2.0 SITE CHARACTERISTICS

2.3 Meteorology

The NRC staff has prepared Sections 2.3.1 through 2.3.5 of this safety evaluation report (SER) in accordance with the review procedures described in NUREG-0800, "Standard Review Plan for the Review of Safety Analysis Reports for Nuclear Power Plants (LWR Edition)." Input to these SER sections was developed based on the staff's evaluation of the information presented primarily in: (1) Section 2.3 of the Clinch River Nuclear (CRN) Site ESP site safety analysis report (SSAR) (Revision 1) (Agencywide Documents Access and Management System (ADAMS) Accession No. ML17362A298); (2) the applicant's responses to NRC staff requests for additional information (RAIs); (3) the staff's assessment of technical information and supporting analyses discussed during an audit conducted in May 2018 (ADAMS Accession No. ML18248A113); and (4) generally available reference materials identified in applicable sections of NUREG-0800.

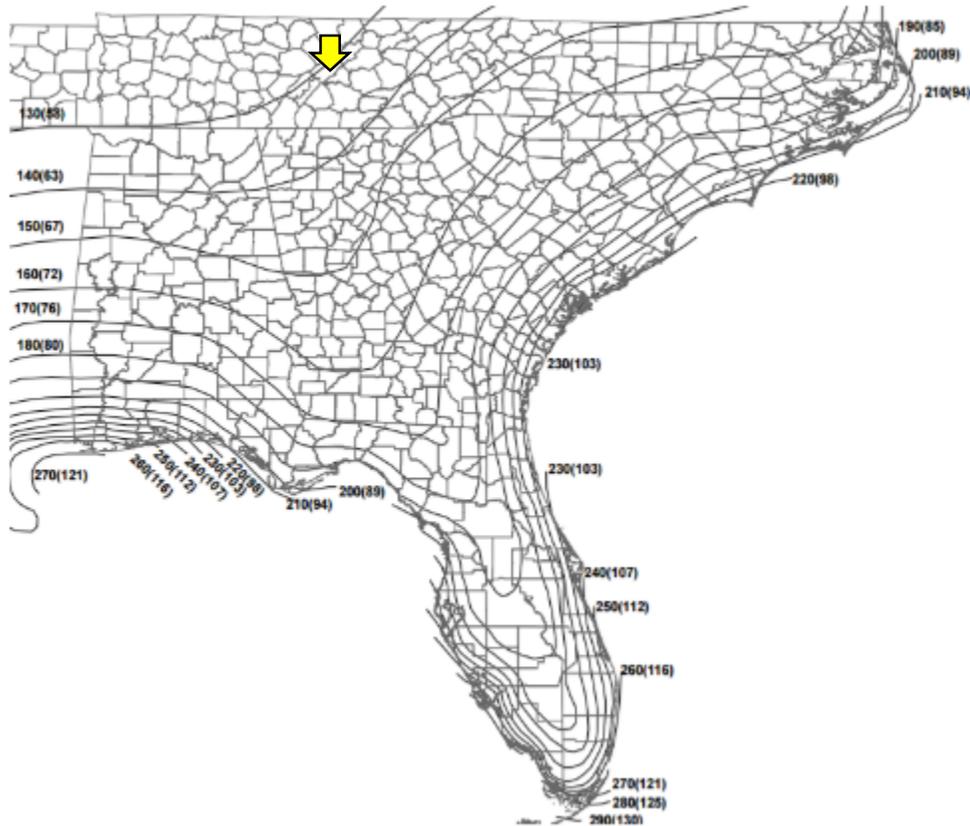
The applicant stated that they reviewed both RG 1.221 and NUREG/CR-7005 and came to the conclusion that because the site lies at an extended distance from the coast, hurricane winds will not present a safety concern for the proposed CRN Site; the 3-second gust wind speed contours provided in RG 1.221 and NUREG/CR-7005 (below) cease at 130 mph after certain distances inland from the U.S. coasts, as can be seen in Figure 2.3-1 of this SER.

The applicant provided a site characteristic hurricane wind speed of 130 mph (3-second wind gust speed) in Table 2.0-1. Based on Figure 2.3-1 of this SER, which is reproduced from RG 1.221 and confirms applicant's site hurricane wind speed, the NRC staff agrees with the applicant's conclusion and finds this information acceptable.

Figure 2.3-2 Effluent Release Zones with Analytical EABs

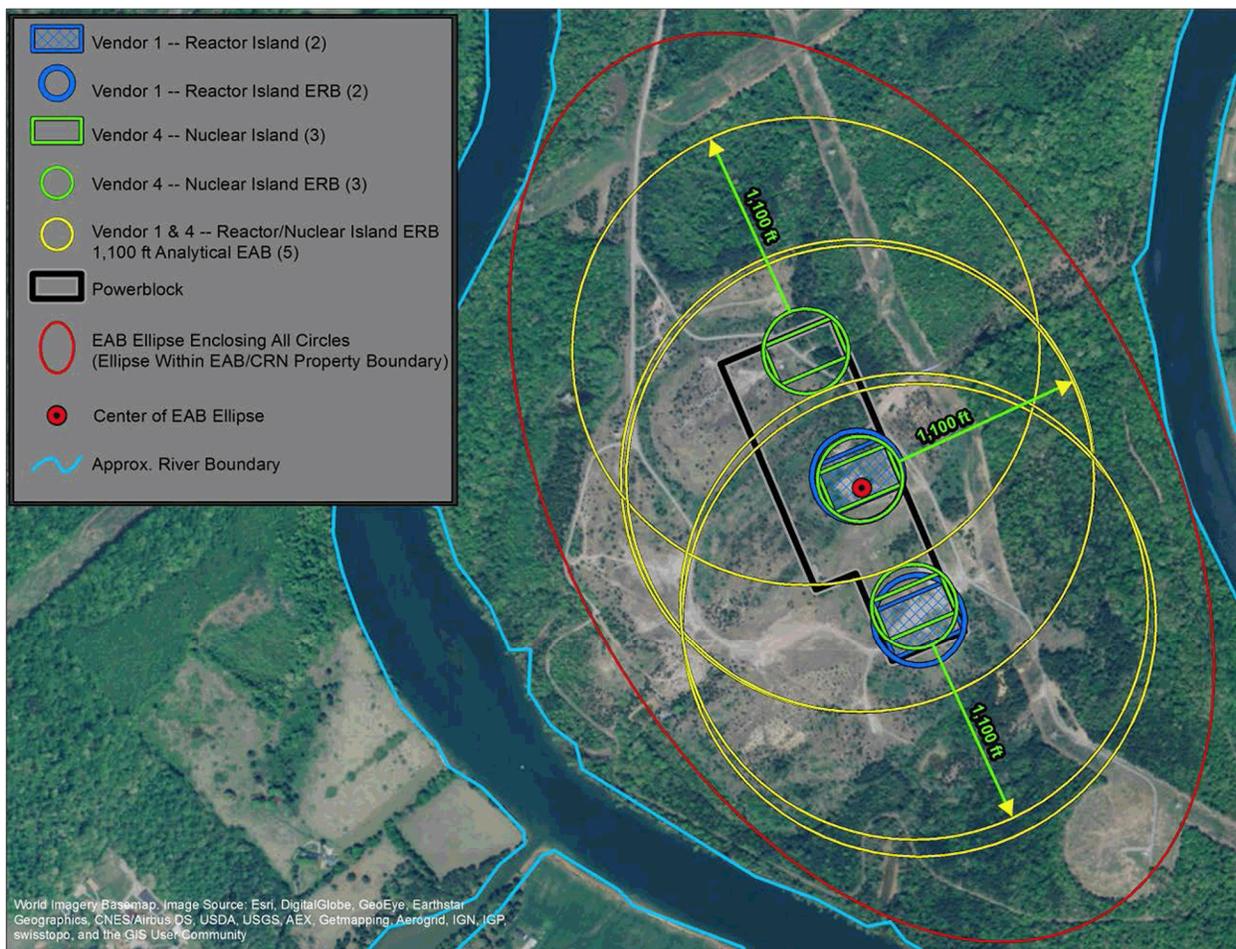
RG 1.145 requires that, for each of the 16 compass sectors, the distance to the EAB should be the minimum distance between the release point and the EAB within a 45-degree sector centered on the compass direction of interest. For conservatism and simplicity, the effluent release point is evaluated as a circular effluent release boundary (ERB) that encloses potential release points from the nuclear island as shown in Figure 2.3.4-1 [reproduced below as Figure 2.3-2]. A circular analytical EAB is established 1100 ft (335 m) from the ERB. For χ/Q modelling (SSAR Table 2.3.4-11), the analytical EAB is used as a bounding representative distance to the EAB. To account for multiple units on site, nuclear islands are positioned at multiple locations within the power block area with associated ERBs and EABs as shown in SSAR Figure 2.3.4-1. The analytical EABs can be encompassed by an ellipse fixed completely within the CRN Property boundary, i.e. the actual EAB (SSAR Figure 2.3.4-1), which demonstrates that dispersion factor computations are conservative.

As described in SSAR Section 2.3.4.2, "Calculation Methodology and Assumptions," "the nuclear island ERB is used to conservatively enclose all possible release points for the selected reactor technologies. The distance from the outer edge of the power block area to the EAB is 335 m (1100 ft), as shown in SSAR Table 2.3.4-11, "Distances and Elevations for the EAB and LPZ in the 16 Wind Direction Sectors," and SSAR Figure 2.3.4-1 (reproduced below as Figure 2.3-2). To account for the potential of multiple units on the site, nuclear islands are positioned at multiple locations within the power block with associated ERBs and EABs, as shown in Figure 2.3-2 below. A circular analytical EAB is established 335 m (1100 ft) from the ERB. All of the potential nuclear island sites are bounded by the ellipse shown below that encompasses all of the analytical EAB and is completely contained within the CRN Site. Since the distance from the outer edge of the power block to the EAB is less than the actual distance from the nuclear island to the EAB, and will result in higher (more conservative) χ/Q values, the NRC staff considers the assumptions in the dispersion analysis to be reasonable.

The outer boundary of the LPZ for the CRN Site is a circle surrounding the power block area with a radius of 1609 m (1 mi). The distance from the power block area to the LPZ is shown in SSAR Table 2.3.4-11 and SSAR Figure 2.3.4-2, "Site Center Point and Distance to the LPZ."
